#### CITY OF NORTHFIELD, MINNESOTA HERITAGE PRESERVATION COMMISSION RESOLUTION HPC #2023-020

## A RESOLUTION BY THE HERITAGE PRESERVATION COMMISSION OF THE CITY OF NORTHFIELD, MINNESOA, APPROVING A CERTIFICATE OF APPROPRIATENESS FOR 220 DIVISION ST. S

Archer House Redevelopment
Northfield, MN

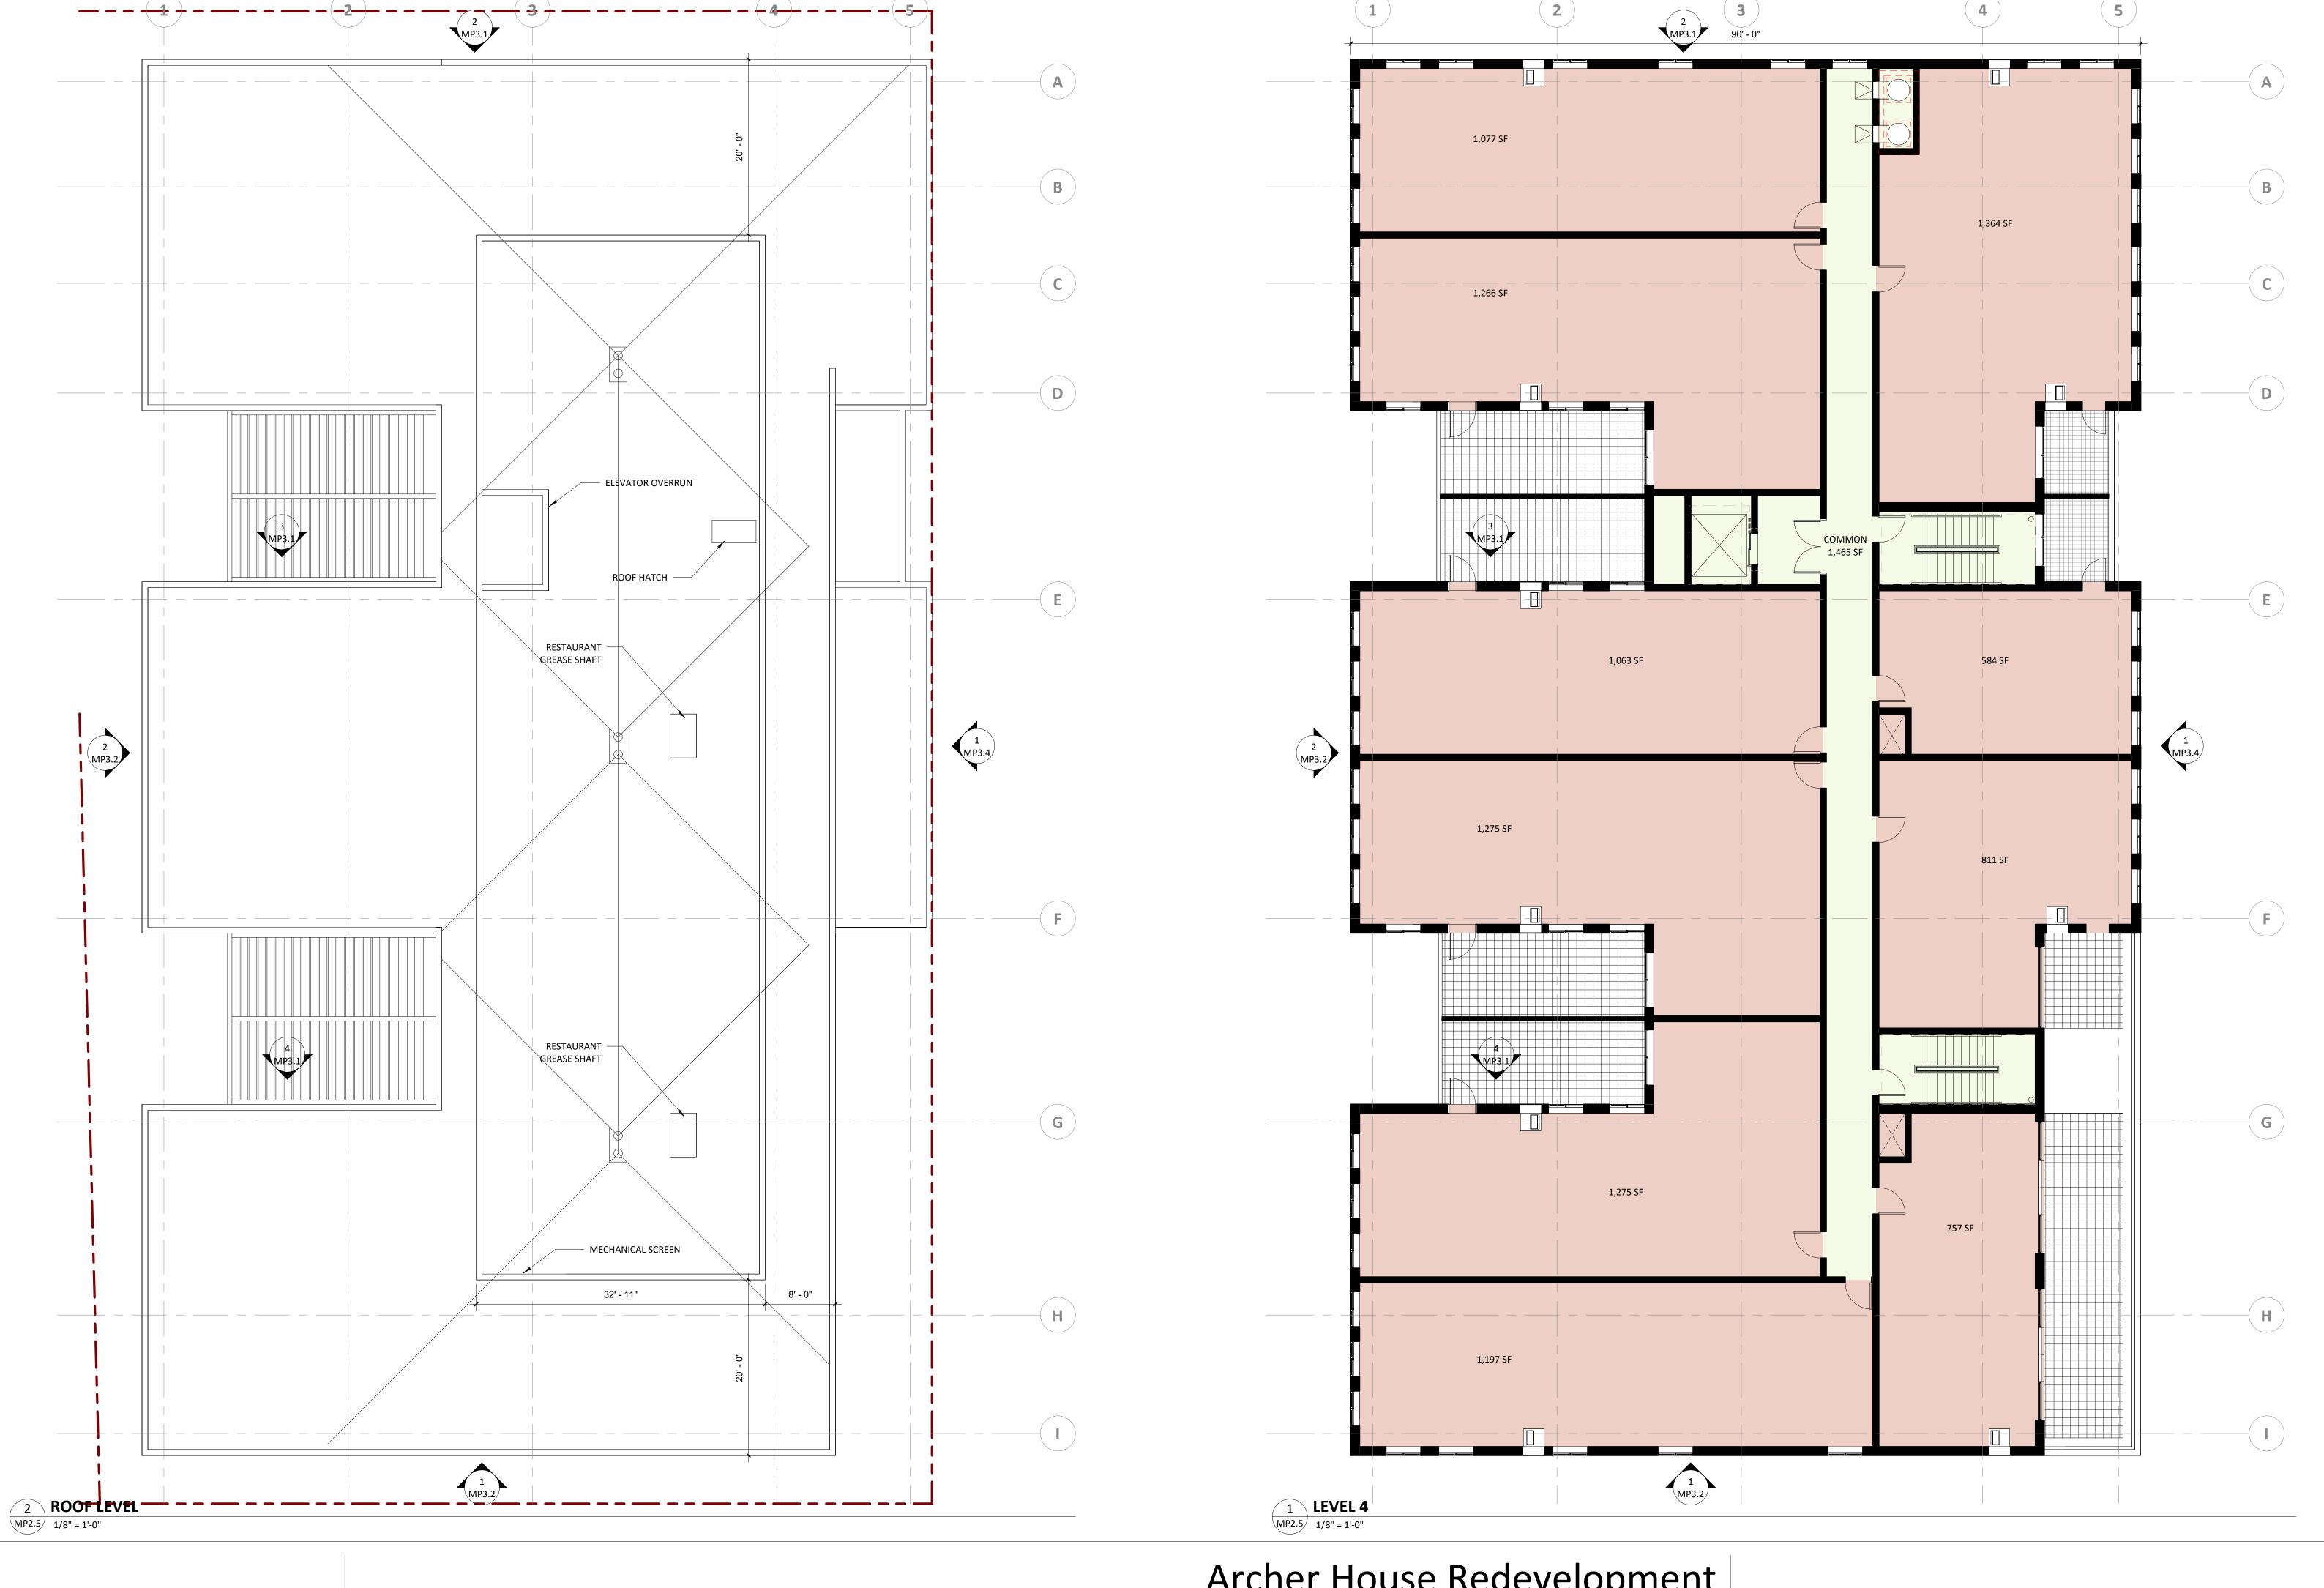
| 2.   | 2. The design element (located above the north entrance to the building along Division St. S. and above "The Archer" signage) will return to the HPC for final approval with a final design and materials. |  |  |  |  |  |  |

Rendered view from 3rd & Washington including mechanical screen

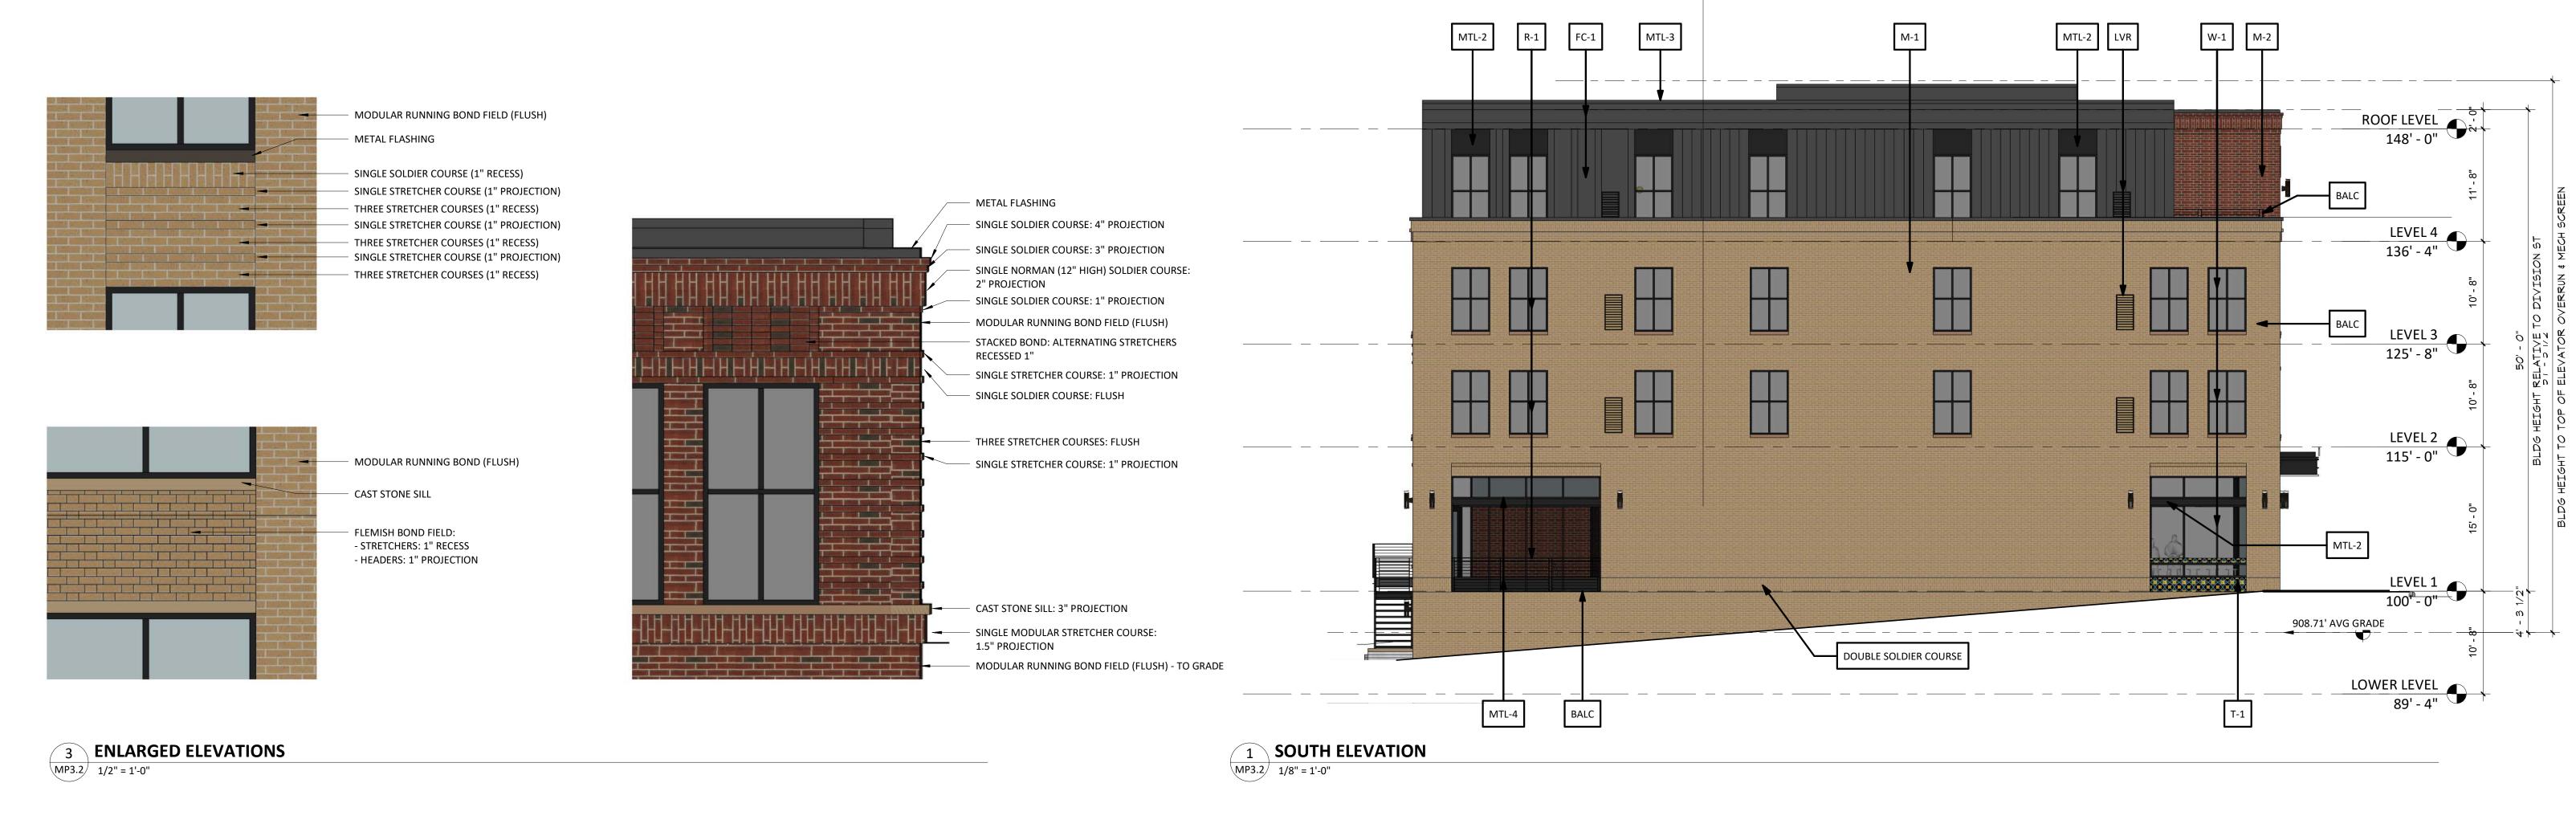
1. The rooftop design is approved with or without the additional mechanical parapet as shown in Exhibit A.
